Staff Report & Recommendation

Design Review Board

SUBJECT: DRB17-0110
8 Farrey Lane

PROPERTY: **8 Farrey Lane**

1969 Aerial showing a substantially landscaped front yard on the subject property.

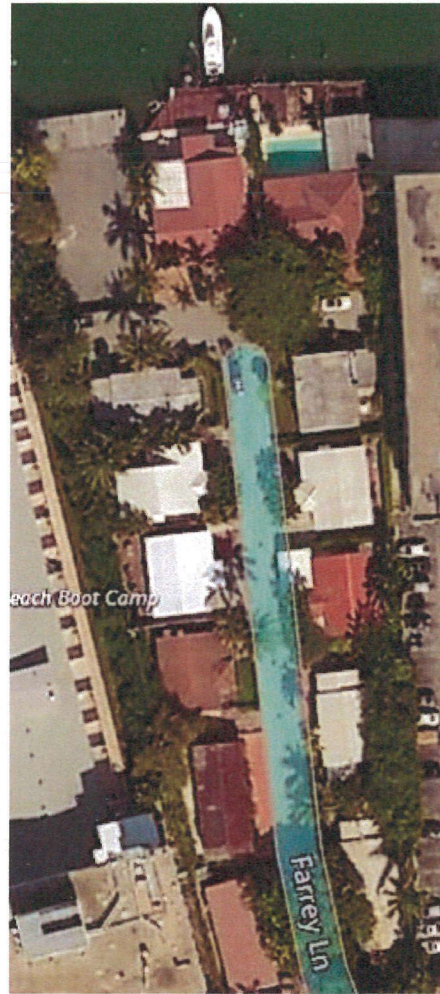
At-grade parking is required to be at a minimum of 5'-0 setback from an interior side property line. The site is currently paved at the front and extends from side to side property lines. As of the writing of this report, there is no evidence of an approved building permit for the current parking site work conditions. Further, research from historic aerials from 1969 reveals that the property once contained a substantially landscaped front yard, as evidenced in the picture below.

Overall, staff finds that the proposed parking area (100% of the required front yard) to be excessive in nature and not consistent with the character of the residential neighborhood that the City wishes to promote. Further, the amount of paving in the required front yard is antithetical to the City initiative of resiliency and green building practices, which at minimum, require on-site storm water retention. In summary, the variances requested do not meet the practical difficulties or hardship criteria.

1994 Aerial, showing dock configuration

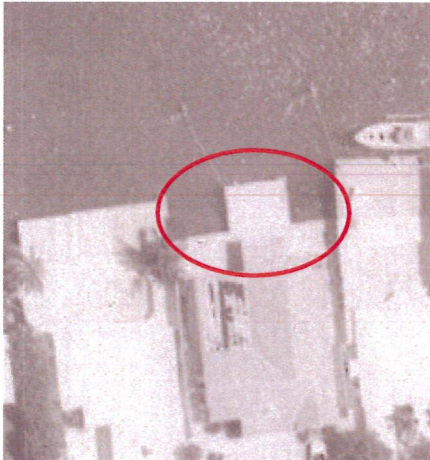
Marine structures are required to have a minimum setback of 7'-6" from a side property line. The existing dock is located at zero setback from the east property line and the applicant wishes to retain the structure. It is not certain when the dock was originally constructed, as staff was not able to find records of a building permit in the building card or in the Building Department records. The dock appears in the City aerial records of 1954 and has remained throughout the years with the same configuration up to 1994. It appears that the dock was expanded to its current setback configuration within 1994 and 2001, as noted in the aerial views below. So far, there is no evidence of the City approval for the dock extension up to the east property line.

Based on these findings, staff recommends that the dock be modified to comply with the required side setback.
